# PRIVATE WATER DISTRIBUTION SYSTEM IMPROVEMENTS TO SERVE WSU PARKING GARAGE #1

WICHITA STATE UNIVERSITY  
 PROJECT NO. 2018PPW  
 THE CITY OF WICHITA, KANSAS  
 GARY JANZEN, P.E. - CITY ENGINEER  
 OCA 607853

**AS BUILTS**

WATER TITLE SHEET

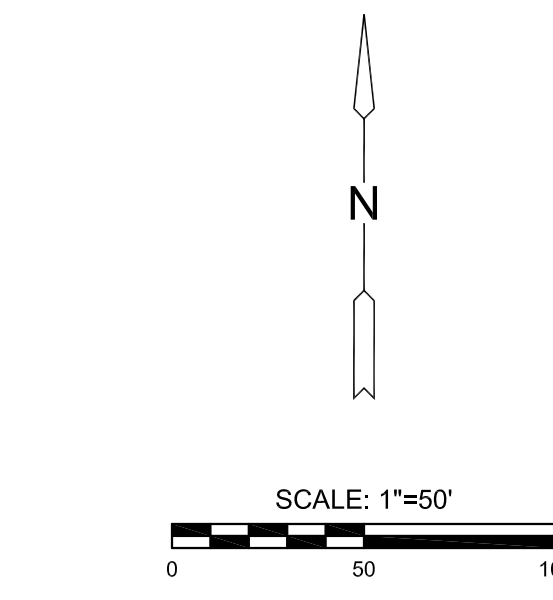
vinylplex 6" C-900 star fittings pro-trace wire

**PLAN WATER LINE 1**  
**PROFILE WATER LINE 1**

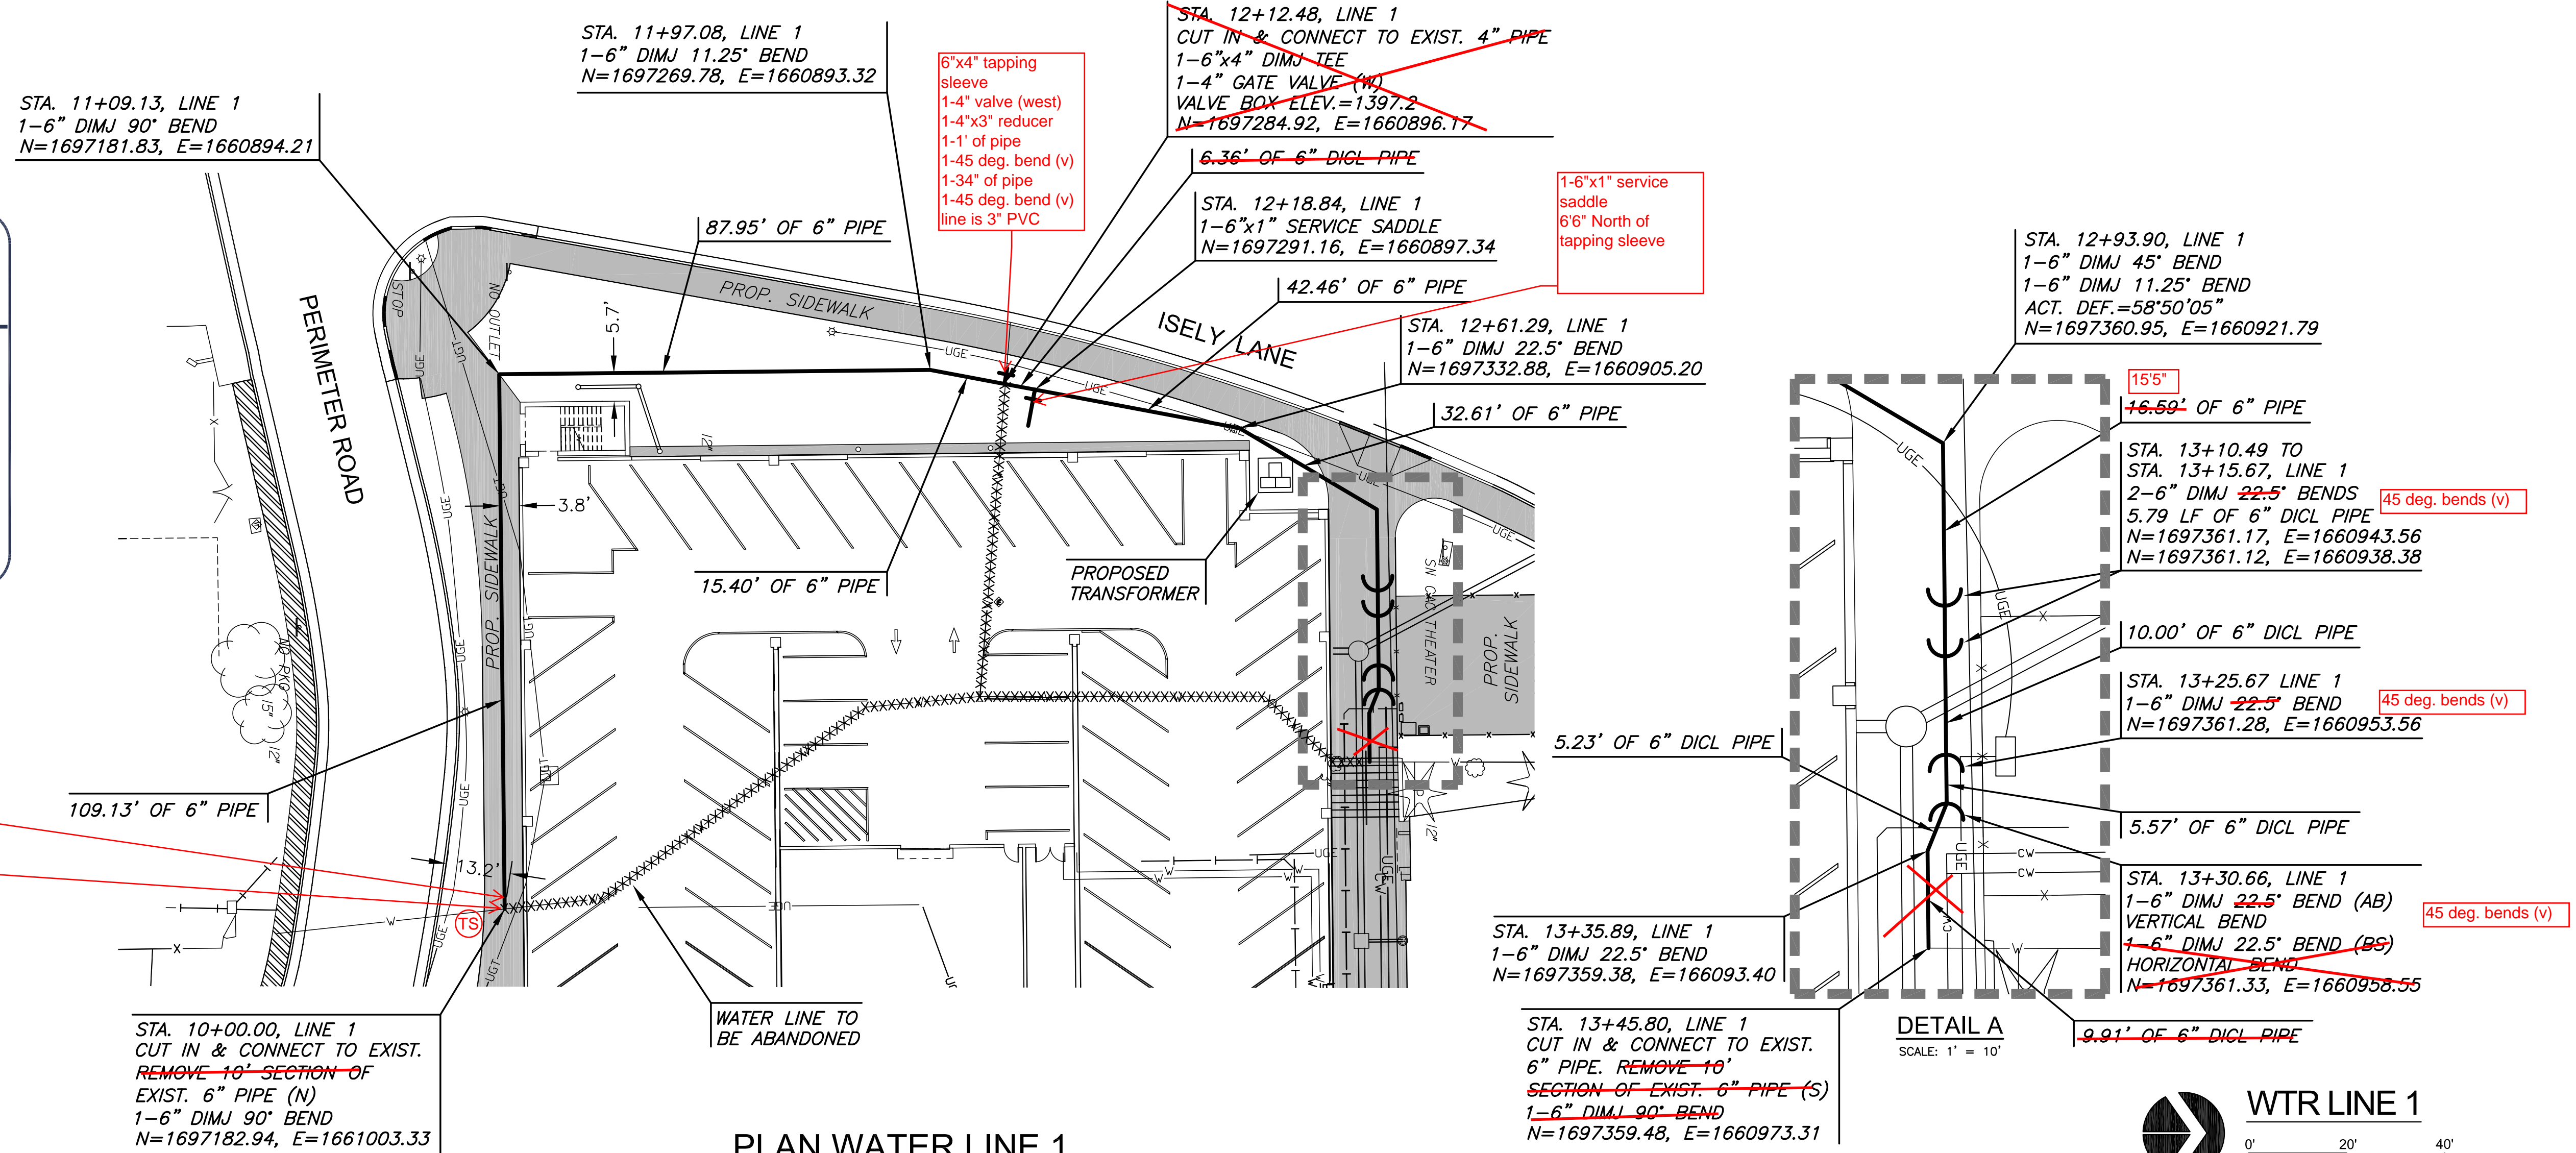
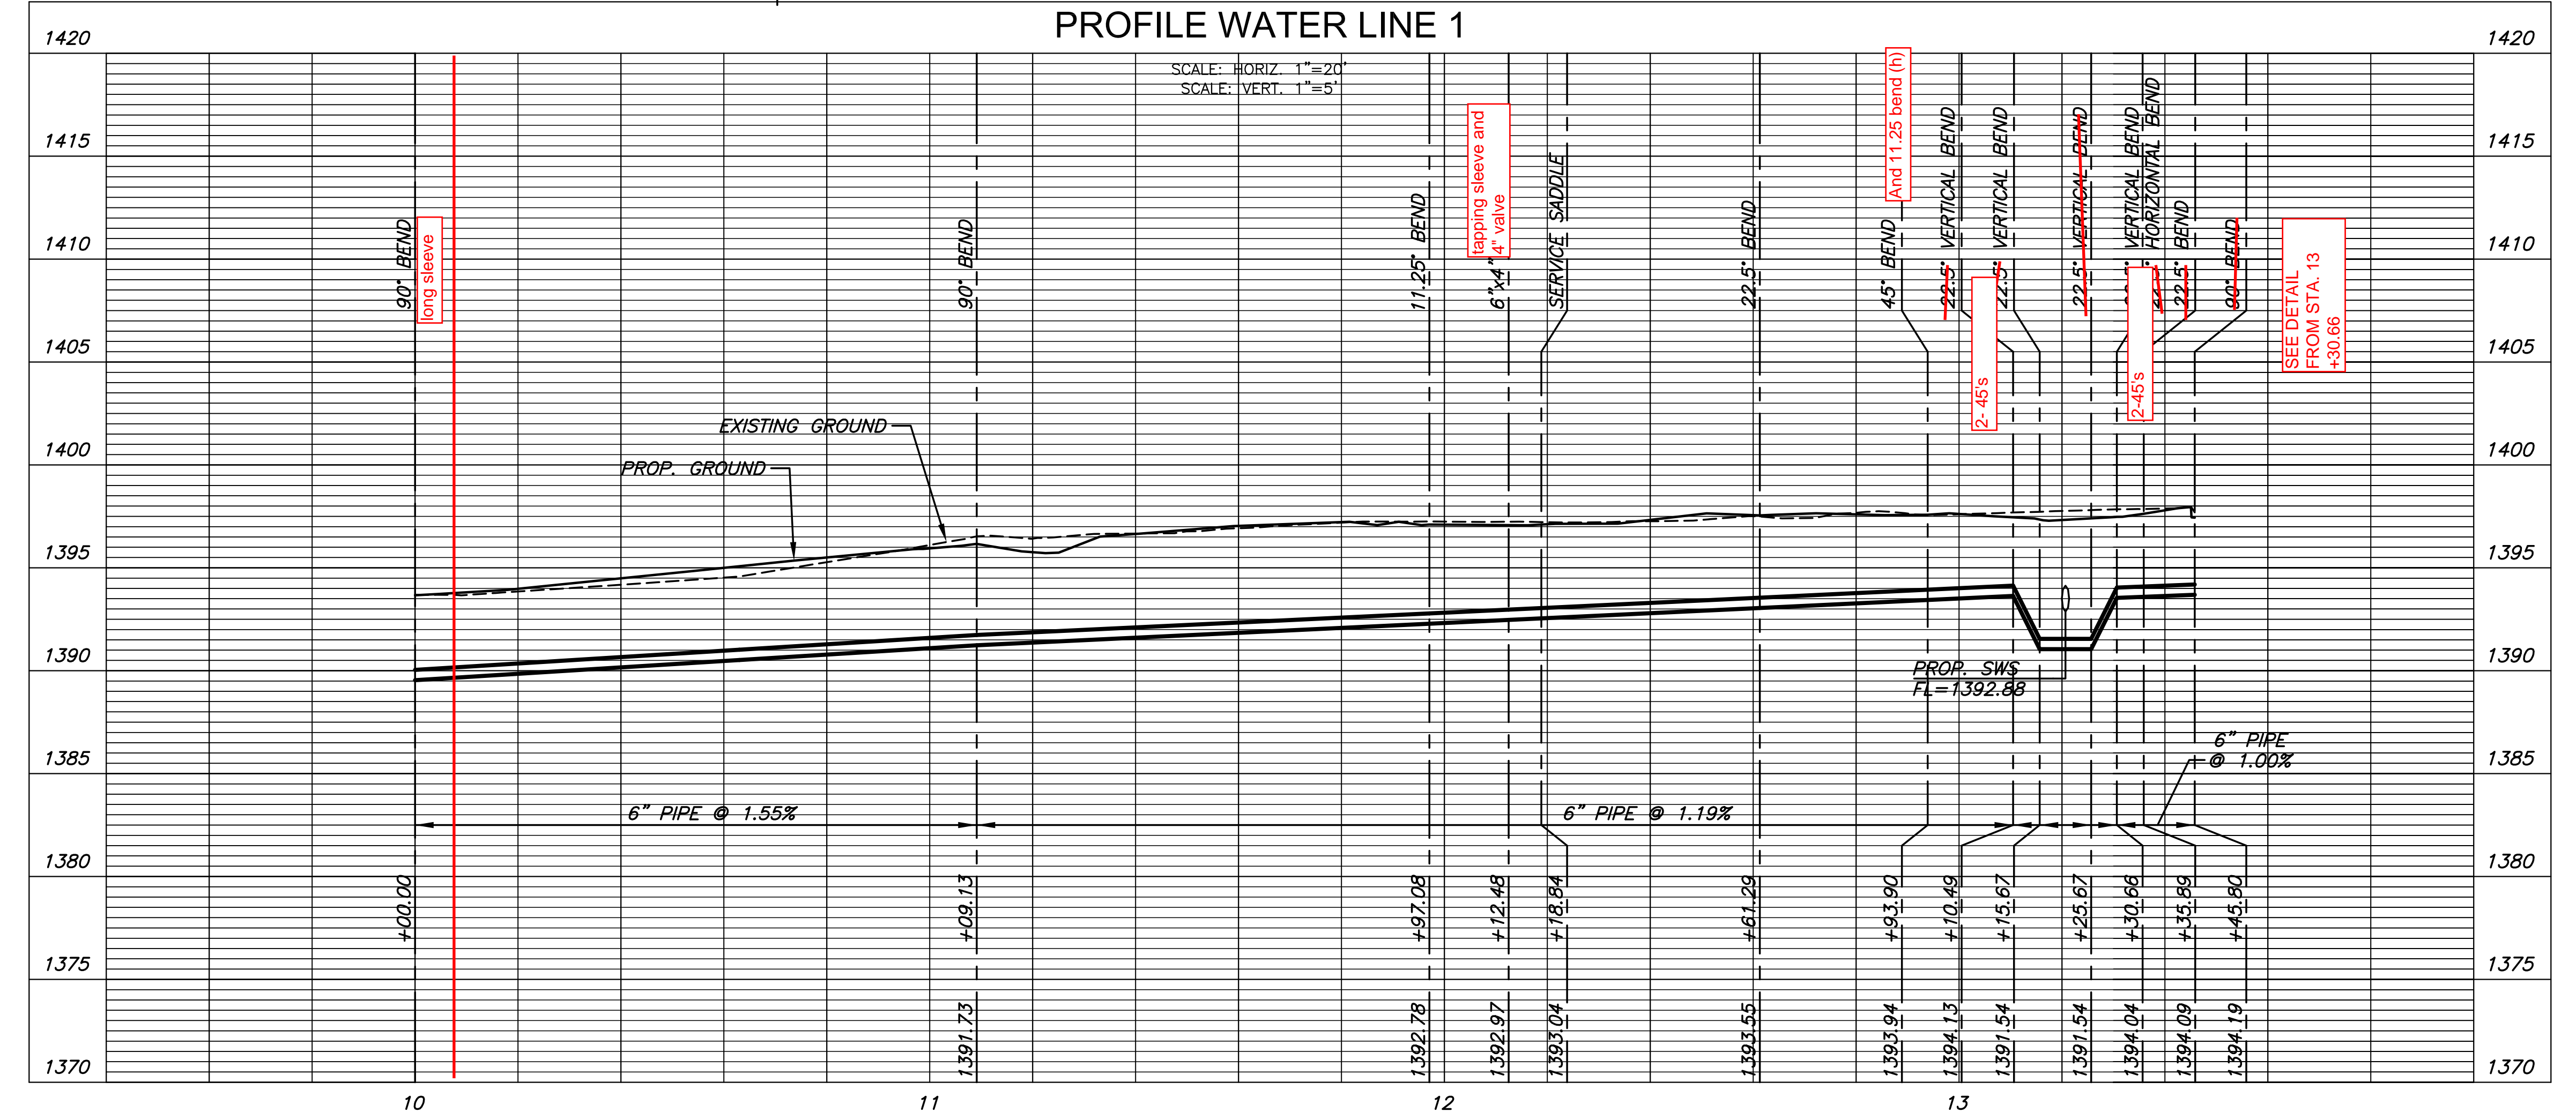
From Sta. 13+30.66  
 megaluged  
 49' of dicl  
 megaluged  
 90 deg. bend (h)  
 megaluged  
 18' of dicl  
 megaluged  
 45 deg. bend (h)  
 Anchor coupling  
 221/2 deg. bend (v)  
 Anchor coupling  
 45 deg. bend (v)  
 megaluged  
 existing 6" dicl pipe  
 TEST STATION at  
 edge of concrete  
 wall  
 From concrete wall  
 West 23' to bottom  
 45 deg. bend
